42 Honeysuckle Drive
42 Honeysuckle Drive, Newcastle

Site
Site Plan

Scale	1 : 500	@ A1	1:1000 @ A3
Drawn	MDJ	Checked	VG
Project no.	s12109		
Status	DA		
Plot Date	27/09/2017 6:06:07 PM		
Plot File	\\lv-vfp-01\home\JD\MD\Documents\42HONEYSUCKLEDRIVE_BS_ARCH_DA_JDM.rvt		
Drawing no.	A01.001	Revision	A

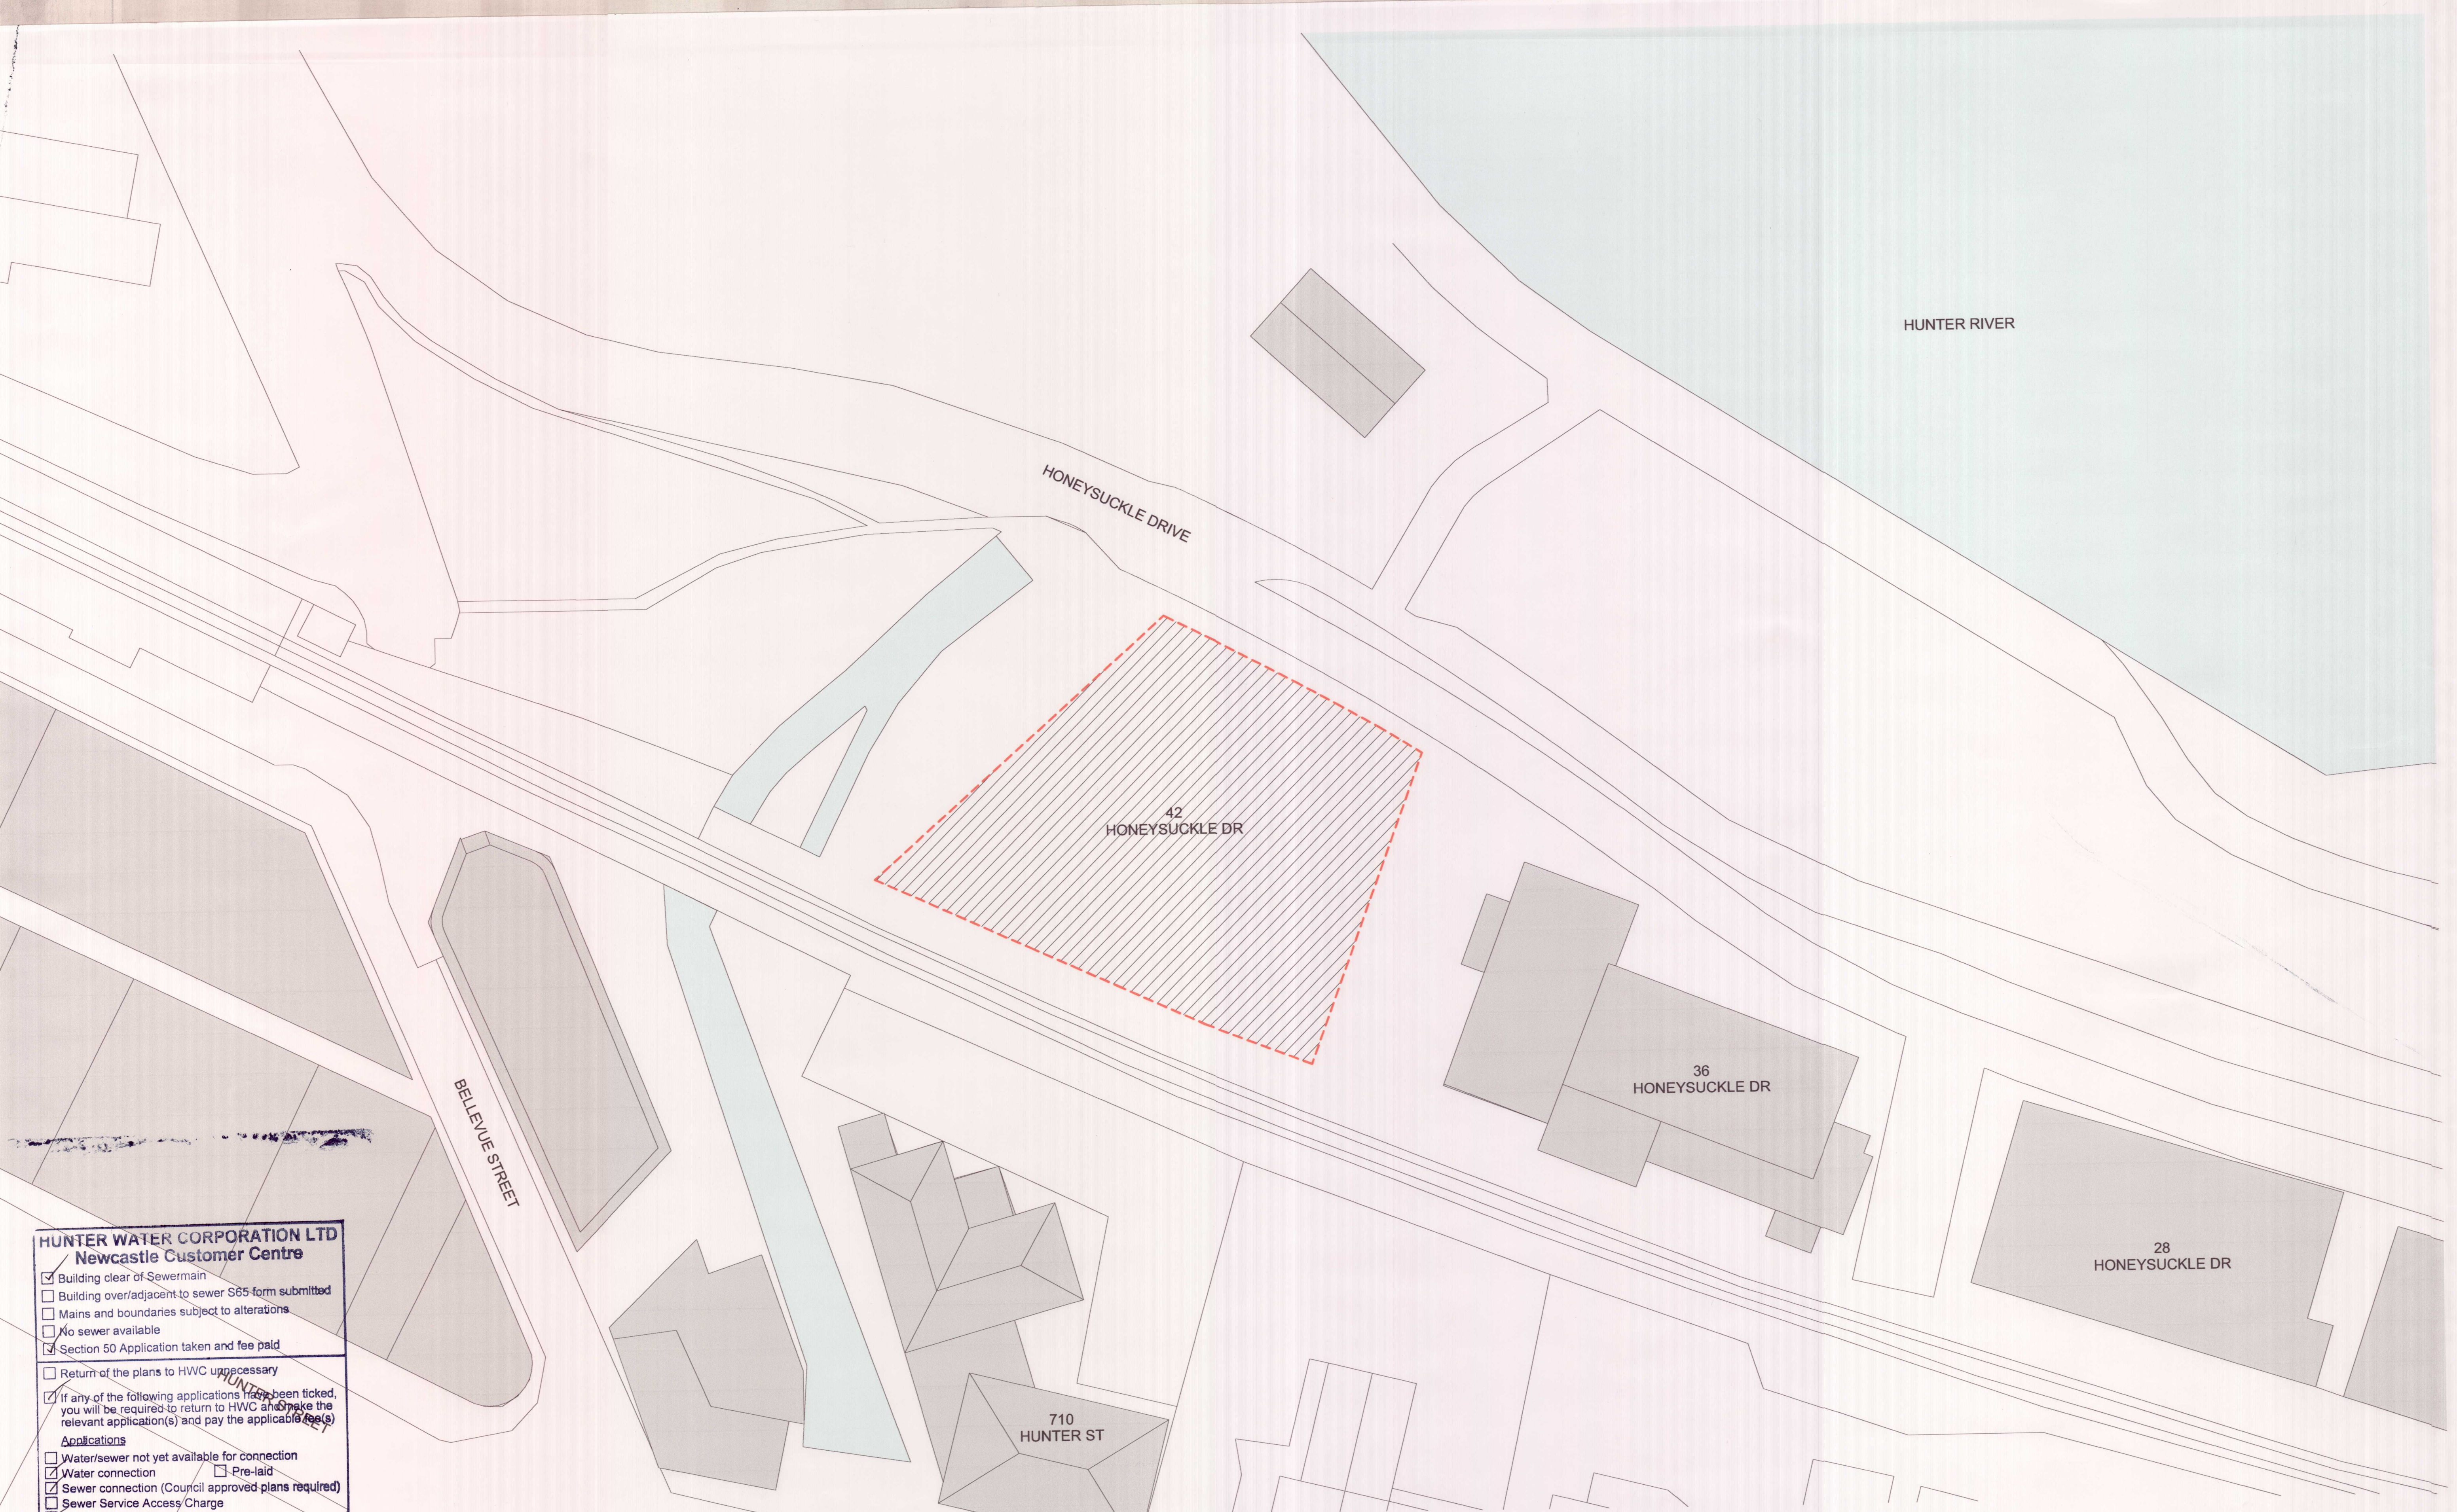
☒ Building clear of Sewermain
☐ Building over/adjacent to sewer S65 form submitted
☐ Mains and boundaries subject to alterations
☐ No sewer available
☒ Section 50 Application taken and fee paid

☐ Water/sewer not yet available for connection
☒ Water connection ☐ Pre-laid
☒ Sewer connection (Council approved plans required)
☐ Sewer Service Access Charge
☒ Hydraulic Drawings (plans required)
☐ Trade Waste
☐ Pressure Sewer Connection
☐ Disconnection of Sewer ☐ Return Water Meter
☐ Systems Charge Applicable
☐ Other

BUILDING CLEAR OF CORPORATION'S ASSETS
CONDITIONS OF CORPORATION'S
EASEMENTS STILL APPLY
